**Case File Number: PLN 19070**

**April 24, 2019**

# CITY OF OAKLAND PLANNING COMMISSION

Case File: ZPI80118  
Applicant: K to College DBA Supply Bank Org.  
Address: 0 Oakport St  
Zone: D-CO-6

SHEET  
**A1.0**

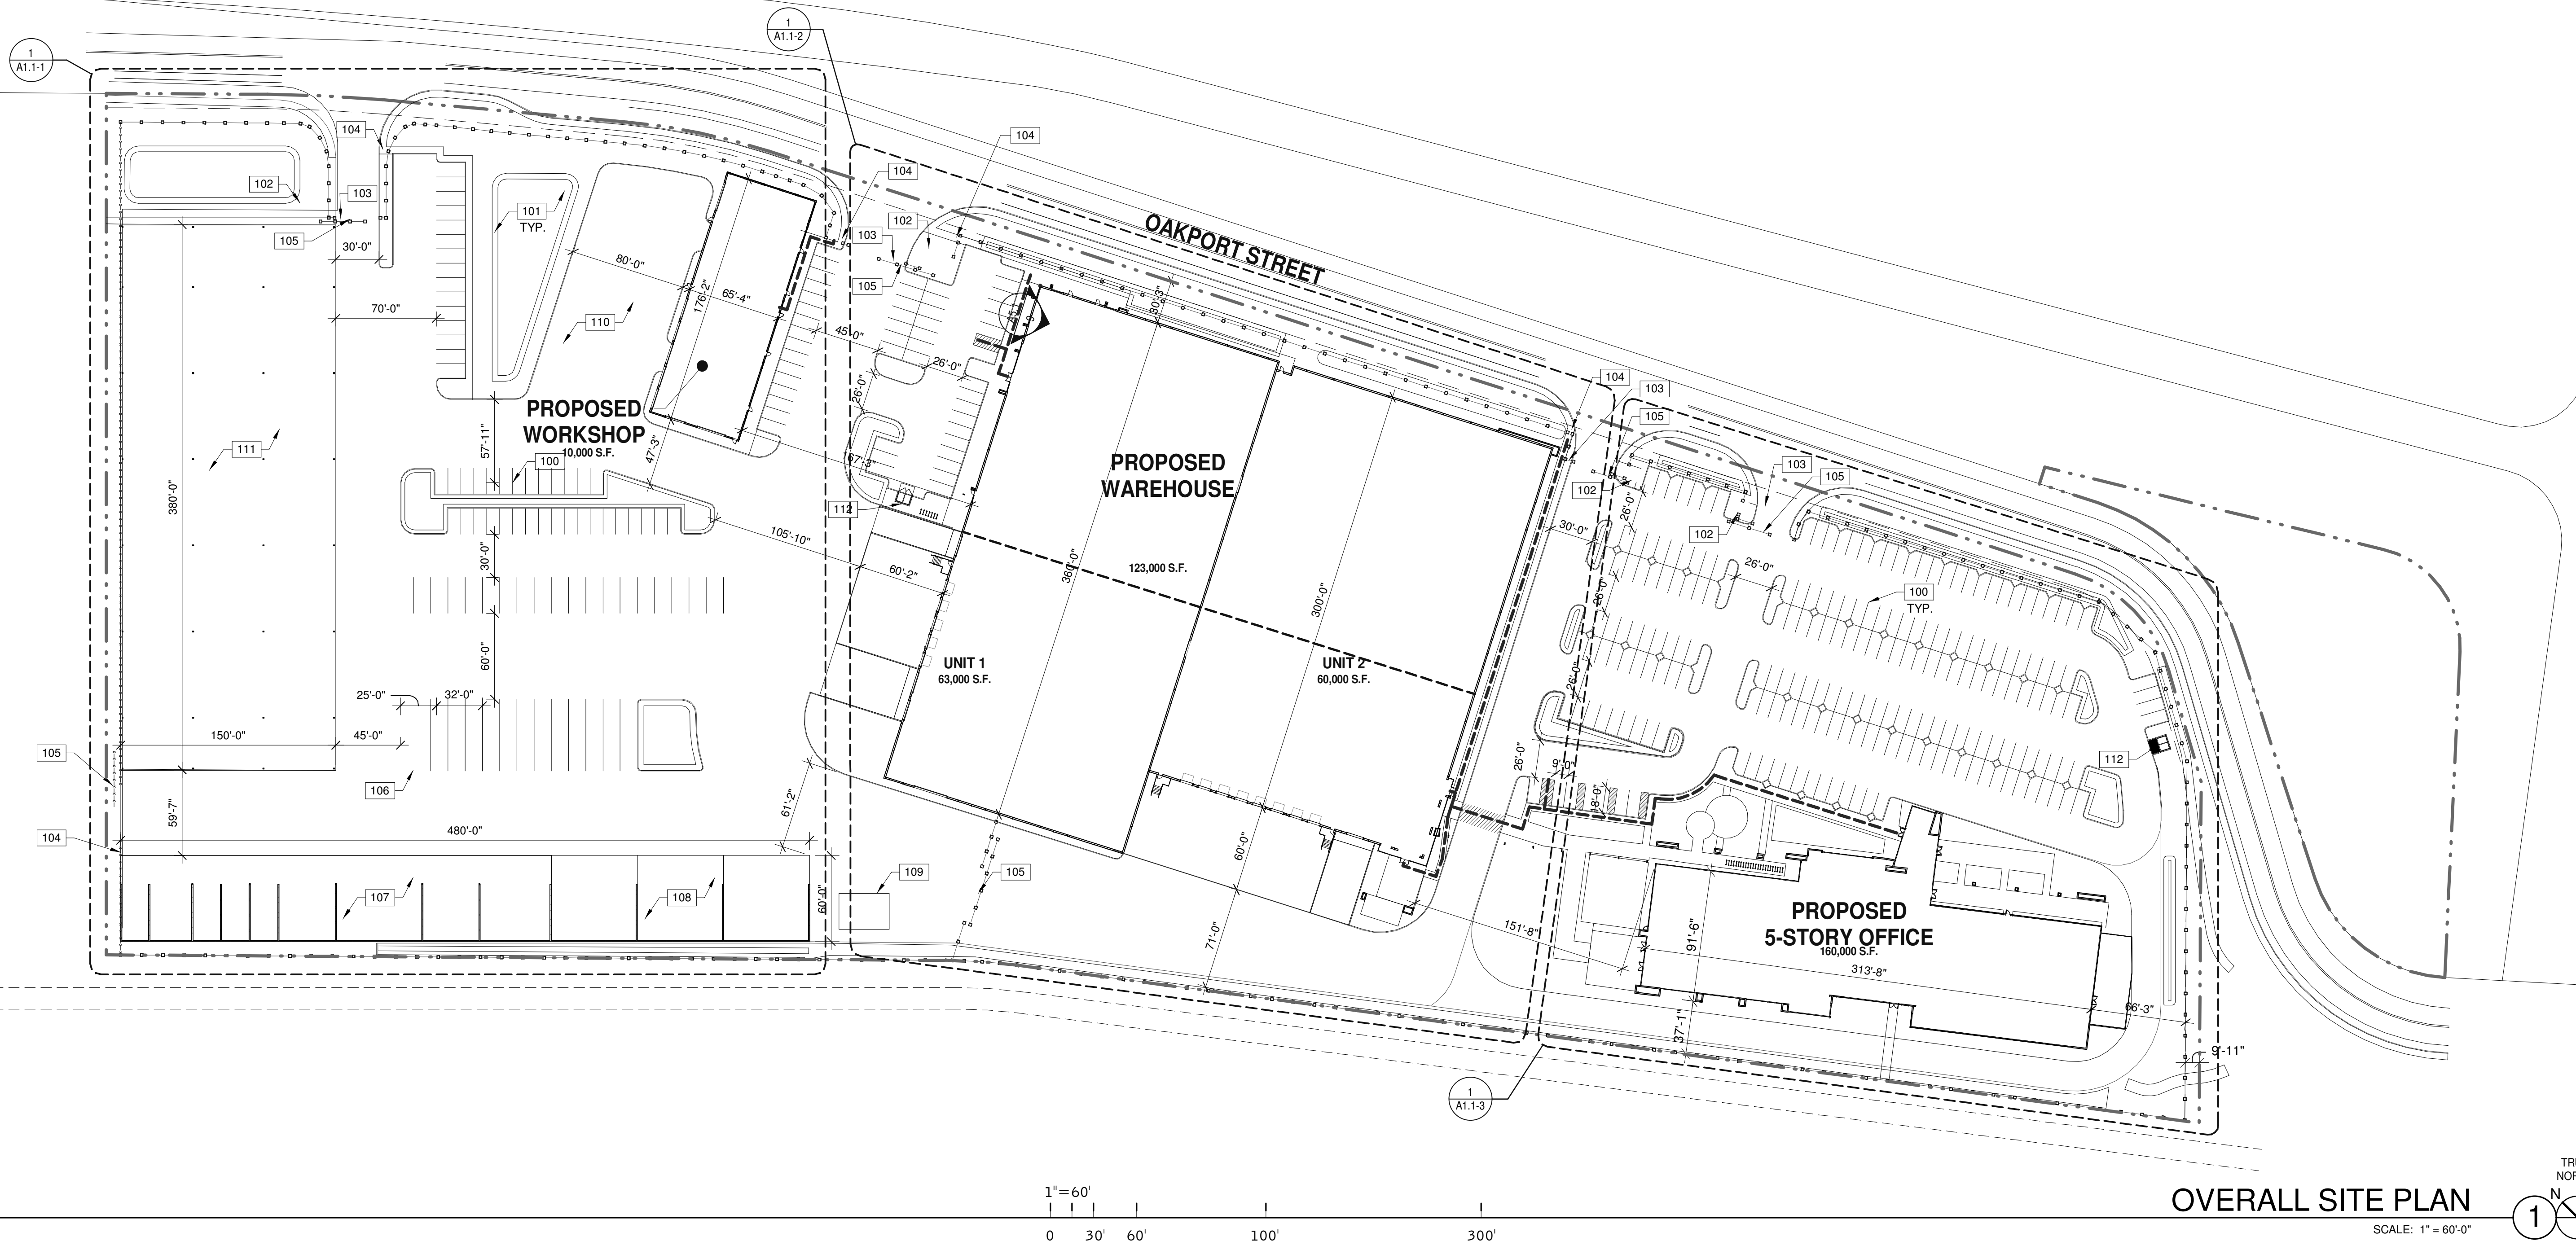
The site plan for Parcel 1 is shown on **Sheet A1.0** and an aerial map labeled to show changes to Parcel 2 is shown on page **C7.0**

The office building is pushed back on the site with a large surface parking lot in the front. This layout is atypical of what we see in other parts of Oakland, but is permitted in this location because the DCO-6 zone does not include a maximum setback standard or any special design criteria intended to create activated street front. The warehouse and workshop buildings and work The Specific Plan Goal for this property is to use the site *in a manner that creates and maintains an attractive frontage along Oakport Street*. The proposed complex of buildings proposed for this site and the landscape plan will accomplish that goal.

**BUILDING 2 - WEST EXTERIOR ELEVATION**

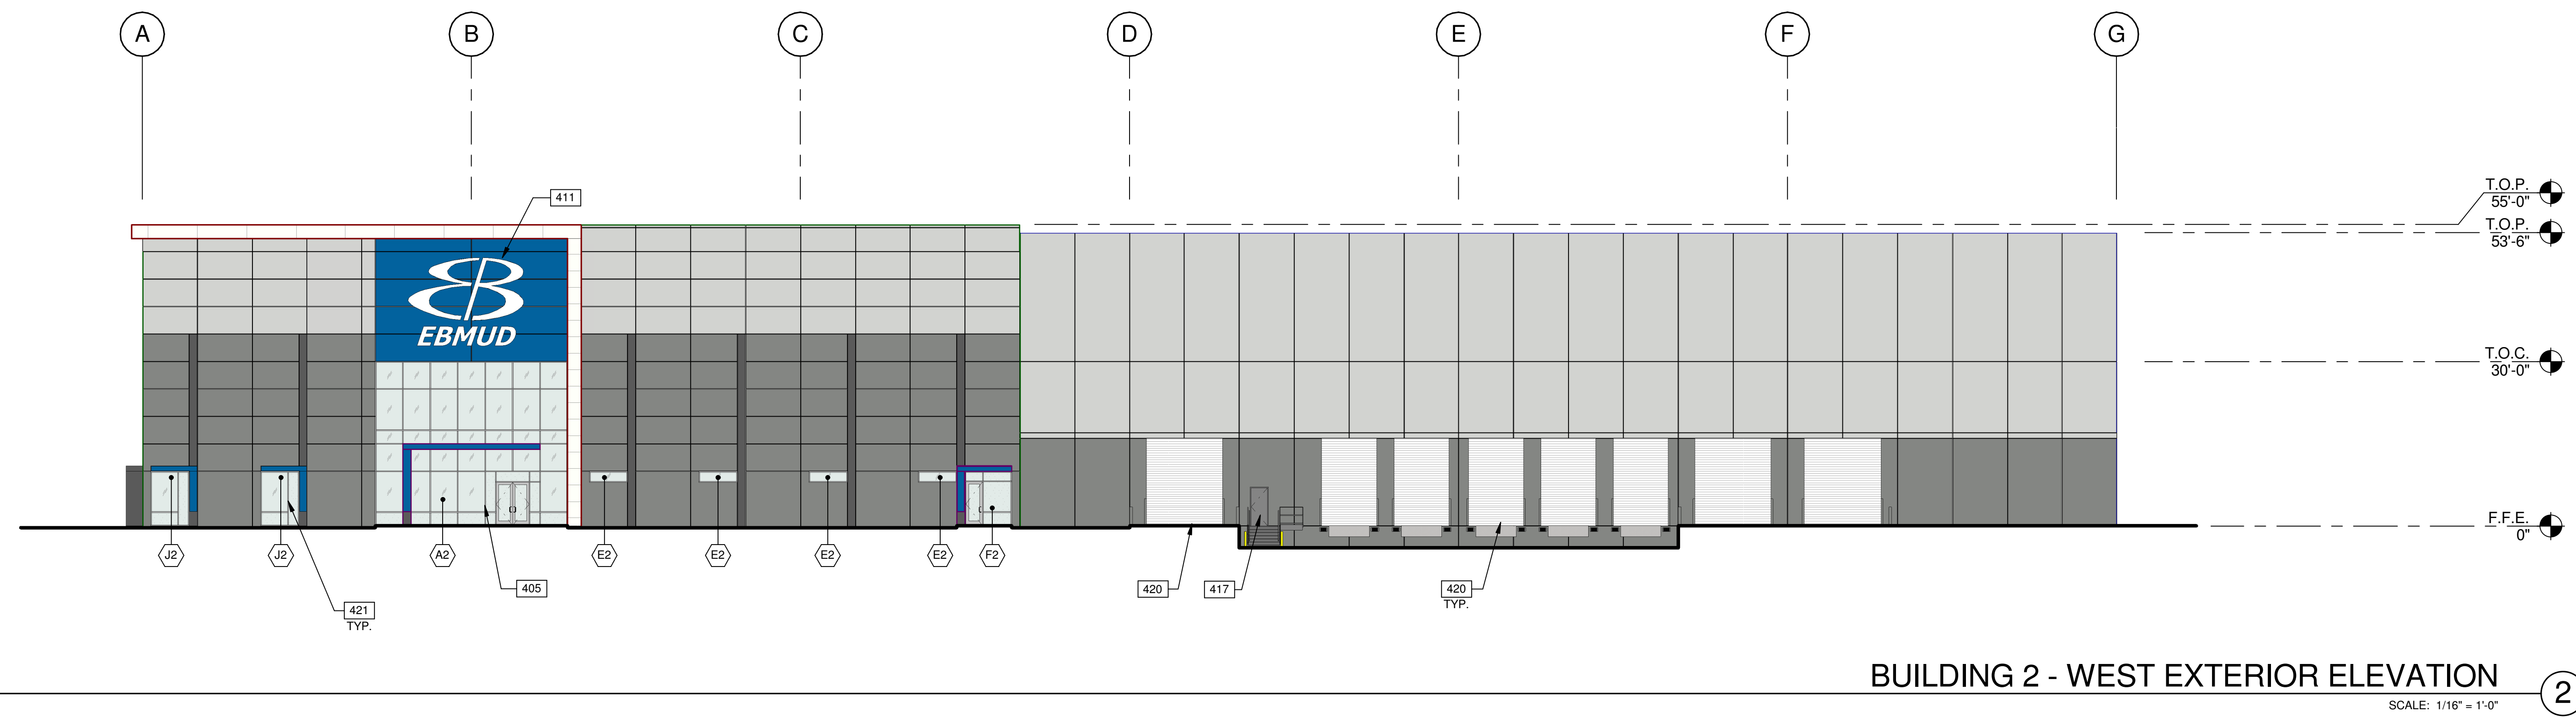
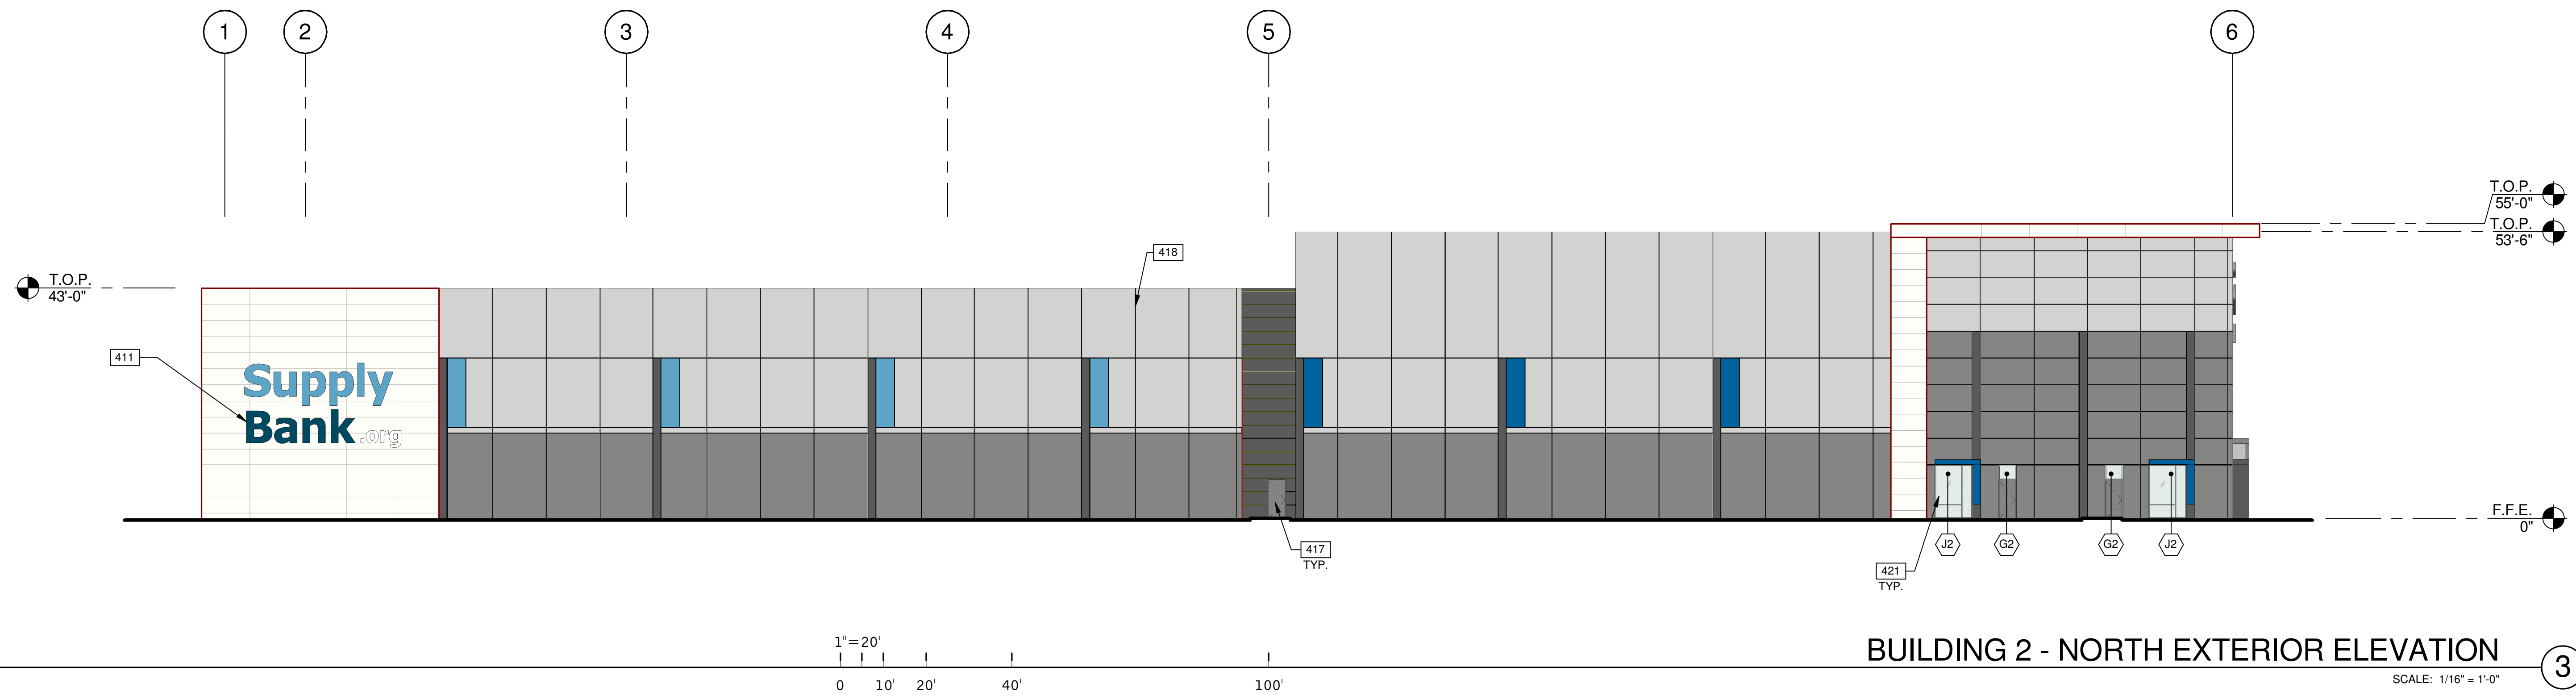
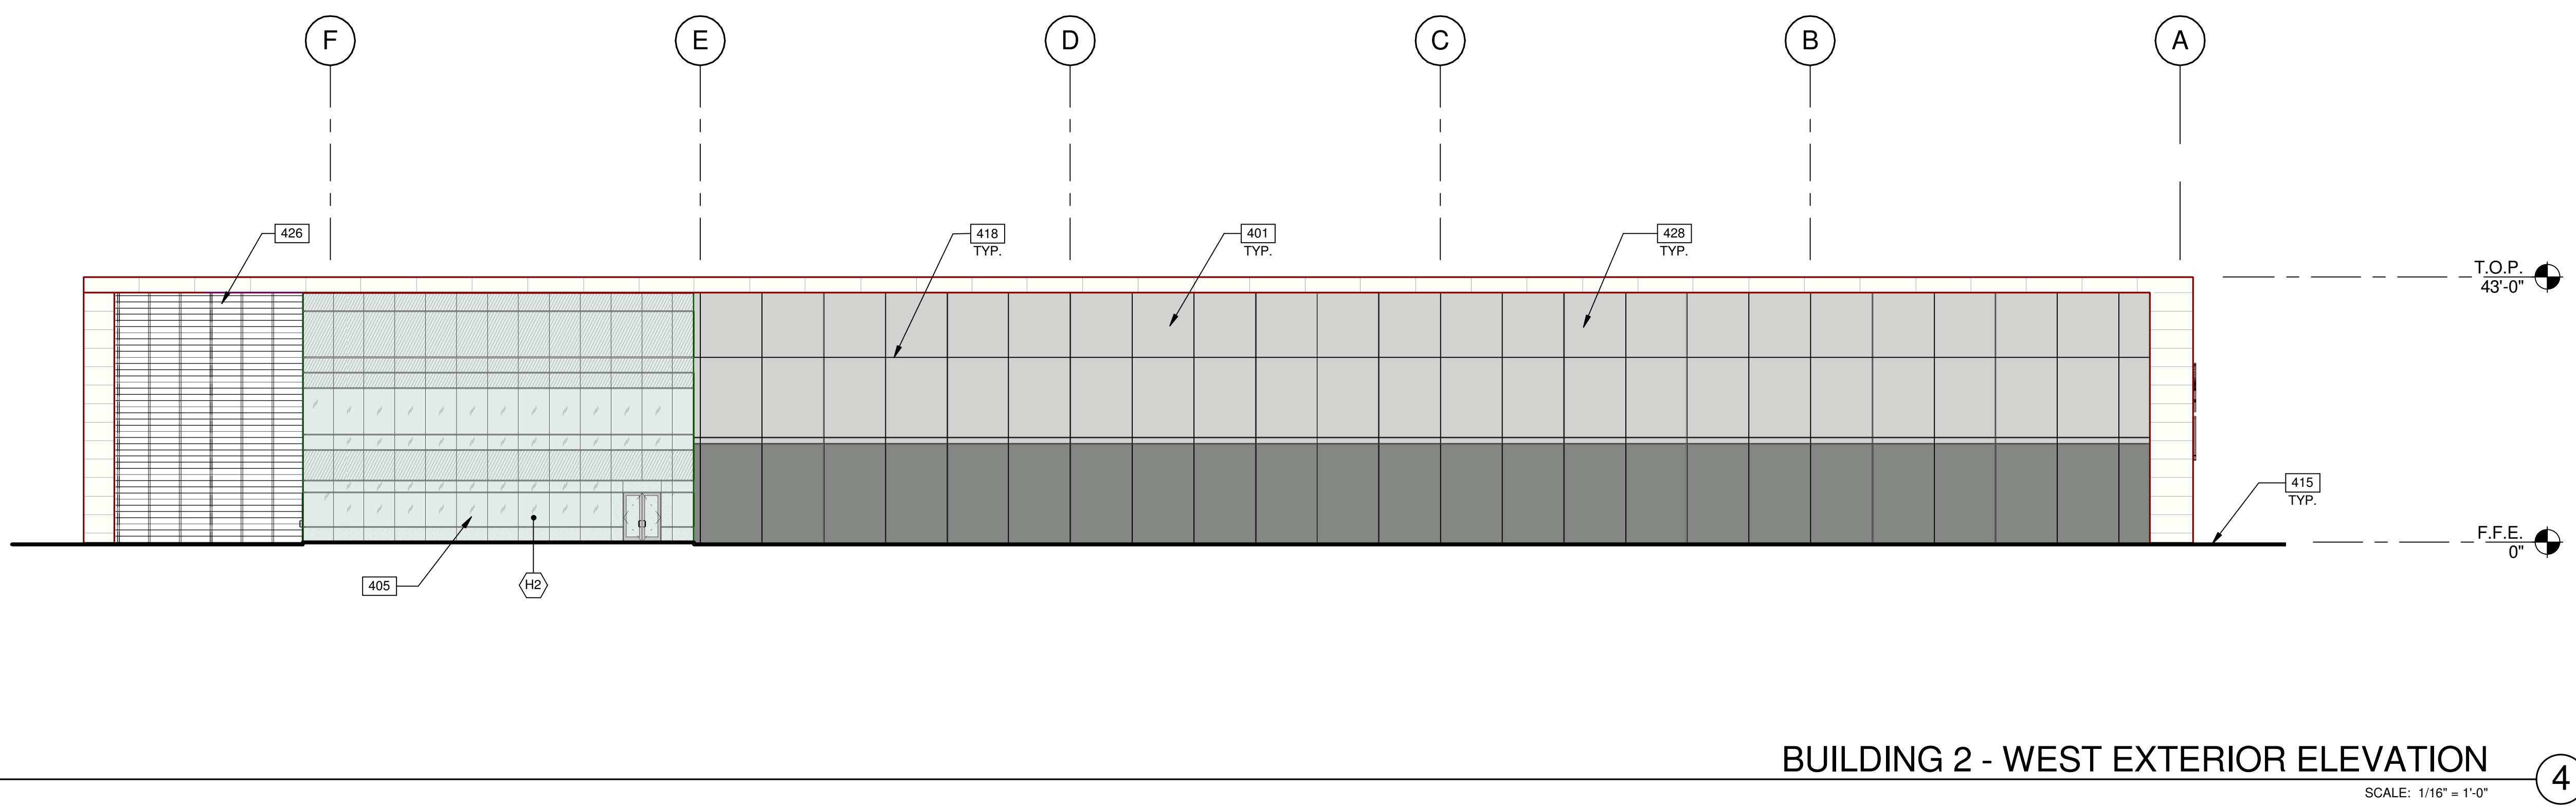
### **2. Warehouse Plan (See Sheet A4.1-2 and A4.12-2 Elevations)**

This building is designed to accommodate the programmatic needs of two organizations. EBMUD requires a higher height and volume to accommodate storage of pipes and a larger accessory office/ employee area, while Supply Bank requires less height and a smaller floor area. The building is 53' high on the EBMUD half and 43' high setback on the Supply Bank portion. In addition, the building is stepped back at the South elevation creating a recessed area that provides loading docks for Supply Bank. The change in height creates more variety in the urban form.

Additional visual interest is created with color. The building uses the same color palette proposed for the small workshop with the darker gray at the base. Blue is added as an accent around the windows and as a repeating pattern on the walls. A trellis is projects from the building at the Supply Bank entry that relates to a walkway to the new office building.
